Illinois Department of Transportation

SUBJECT: Greater Kankakee Airport
Kankakee, Illinois
Kankakee County
Illinois Project Number: IKK-4991
SBG Project Number: N/A
Contract No. KA052
Item No. 04A, November 17, 2023 Letting
Addendum A

NOTICE TO PROSPECTIVE BIDDERS

Clarify daytime/nighttime work and revise storm sewer structures and details.

RESTRICTOR MANHOLE A4 DETAIL

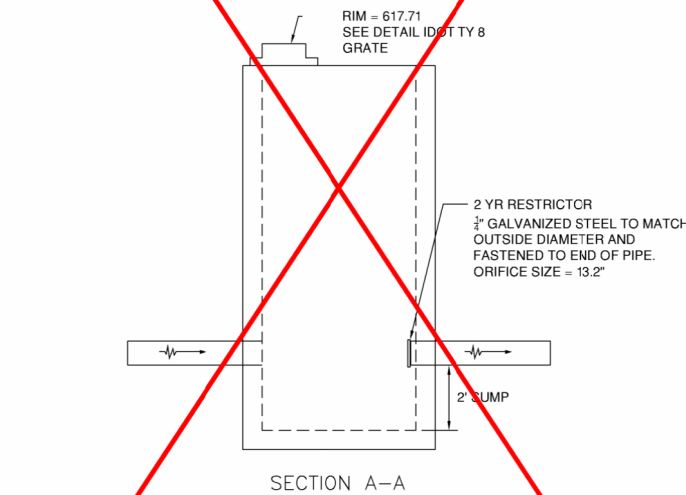
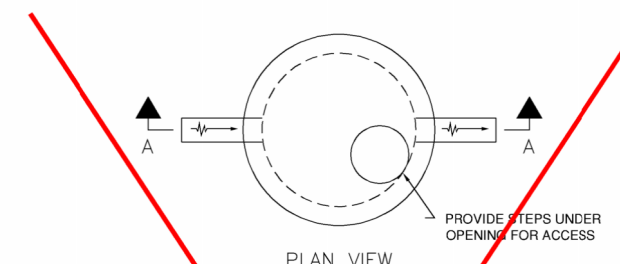
4. Proposed Improvements – 1 (Sheet 17)
 - (a) Revise Structure A3 to New 5' Manhole (AR751550). See attached IDOT Standard 602402-03.
 - (b) Add Notes #8 “See Drainage Details – 1” sheet for location of Structure A4.

- NOTES:
1. MANHOLE IS AN IDOT TYPE A 6" MANHOLE WITH MODIFIED RESTRICTOR AS SHOWN.
